Brem-100-11.03.2014

100 Long Ridge Road: FACSIMILE OF Builderhouseplans.com #HWBDO76503

Pg 203

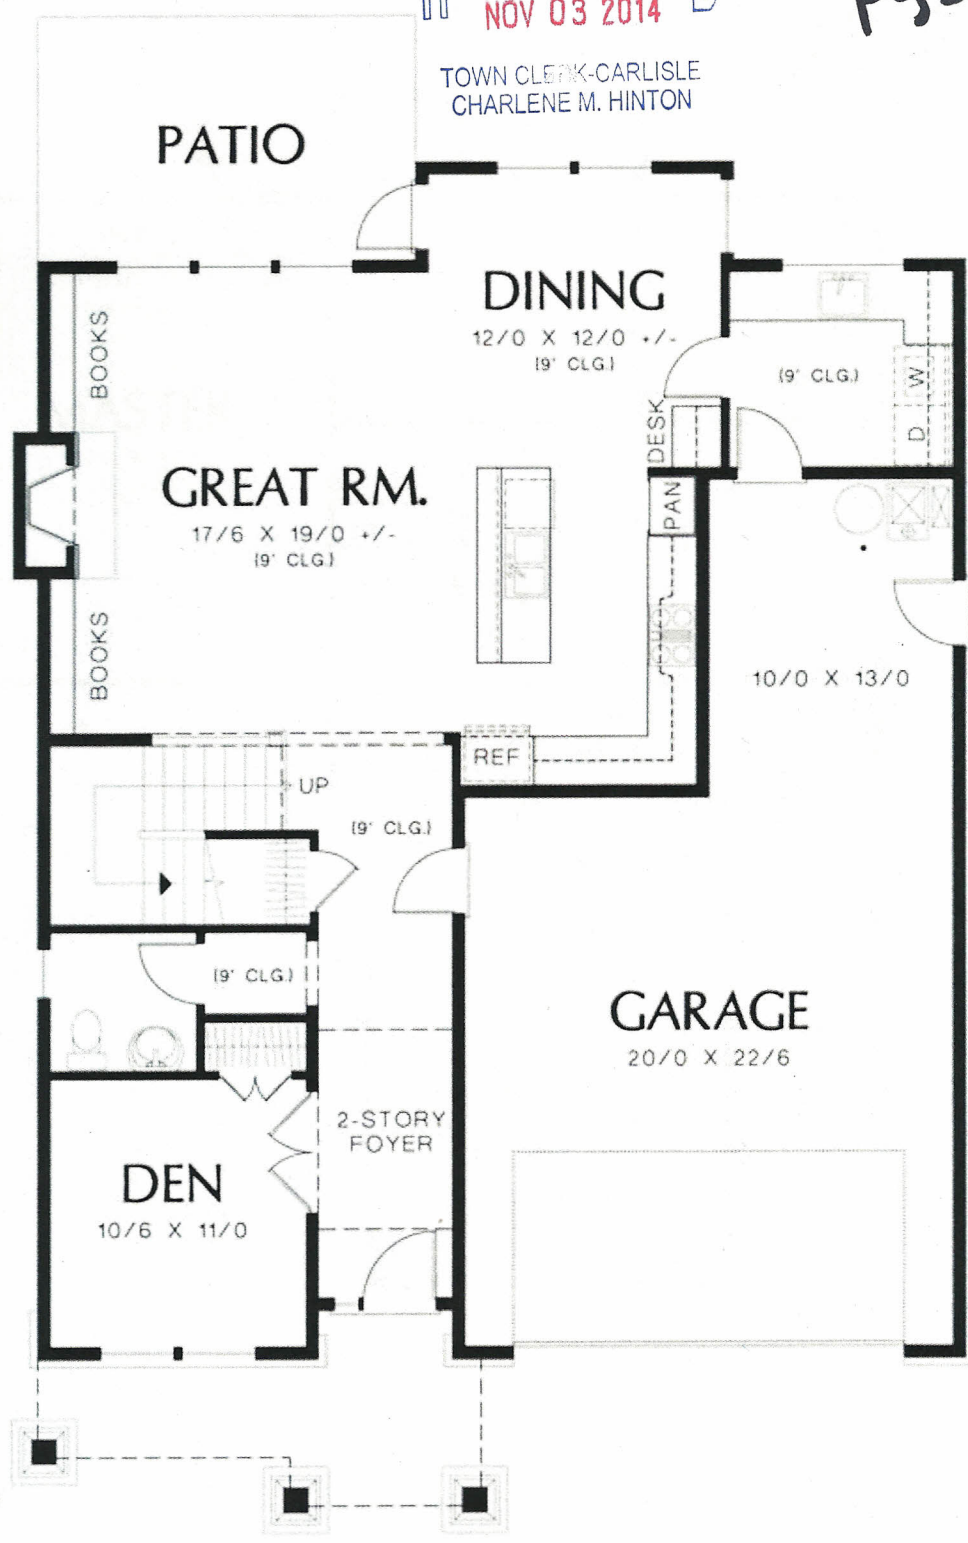
Adjustments to include:

- a. Roof Line – Eliminate Hip
- b. Change Gable Trim with less cantilever and column widths to match other houses
- c. Consistency with Trim Band over 2nd floor windows
- d. Double window to replace triple in MB
- e. Consistency with stone use between all homes
- f. Extend front porch width, if possible
- g. Consistency with roof pitch between units
